Proposed Lidl Store, Bankwood Way, Birstall, West Yorkshire

GB Card & Partners (GBCP) have been commissioned by Beam Consulting Engineers Ltd (Beam Consulting) (the Client) to undertake a geotechnical assessment of the proposed ground improvement works at the above site.

Figure 5: Typical cross-section of foundation and ground floor slab over CMCs

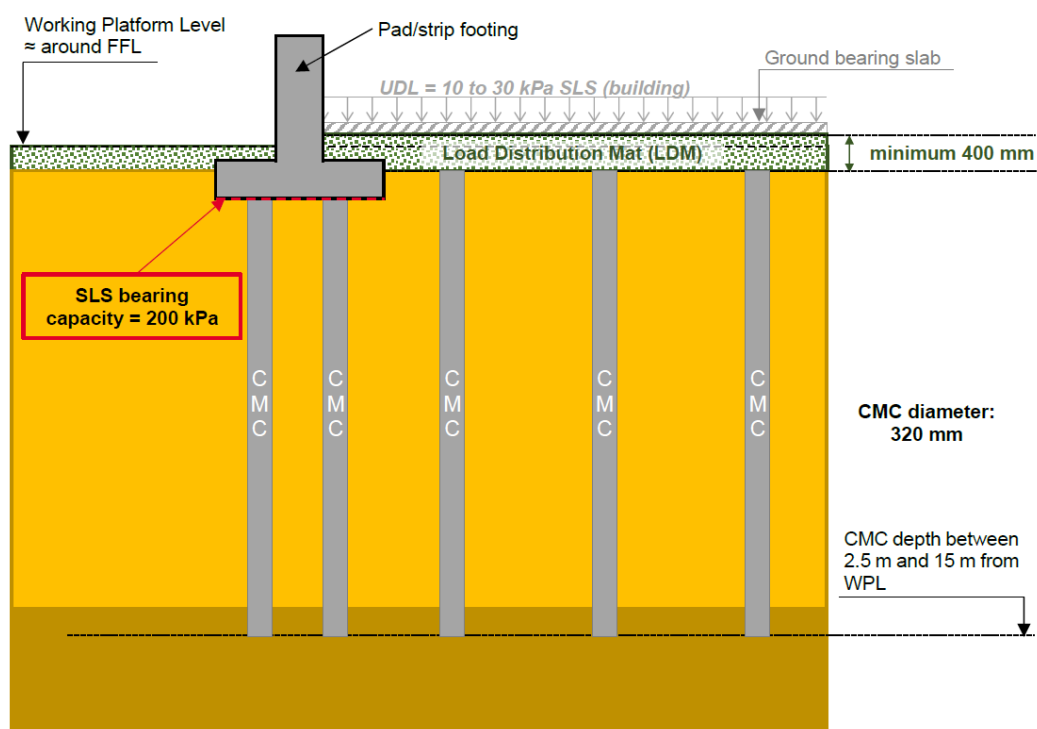
1. The profile of the Pennine Lower Coal Measures Formation varies significantly across short distances. It will therefore be necessary to consider how the base of the columns will be installed without deflection and with sufficient penetration into competent natural material around the edge of the former opencast workings, where interacting with the highwall.

3. It is acknowledged that anticipated total and differential settlements are to be reduced through the application of the proposed method. It is recommended that the design considers the transition between differing foundation types (CMC's/BMC's) to minimise potential differential movements and to maintain transition gradients within acceptable tolerances. It is anticipated the use of the load transfer mat will mitigate the majority of these potential effects.

Figure 6: Typical cross-section of foundation and ground floor slab over CMCs

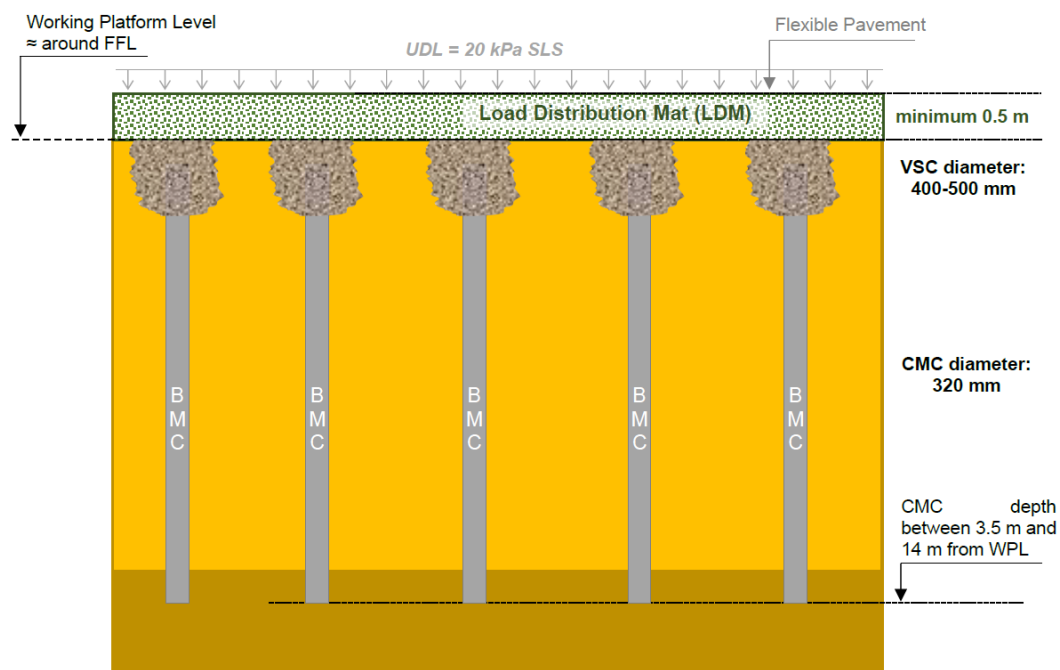
2. It is noted that the waste is described as being within a clay matrix. The clay matrix will generally dominate the geotechnical engineering behaviour of the waste albeit variation will occur given the heterogeneity of the material composition. With landfilling at the site potentially continuing until the early 1990s, it is possible that any biodegradable putrescible materials in the waste are still degrading, albeit most of the degradation should have occurred over the past 30 years. Following improvement, the long-term residual degradation of landfill waste materials, resulting in potentially uneven loss of strength within the soil mass, should be considered. Where long-term settlement occurs within the waste mass, confirmation should be provided that any reduction of support and/or movement will not adversely affect the proposed solution, resulting in excessive movement or collapse of the stone column section.

4. The potential for ground gas migration, particularly within the vibro stone column element of the BMC columns, should also be considered when designing the system. For example, it may not be feasible to locate the base of the stone columns within the landfill waste material, encountered from depths as shallow as 0.8m bgl, which may mean varying the depth of the stone columns across the site.
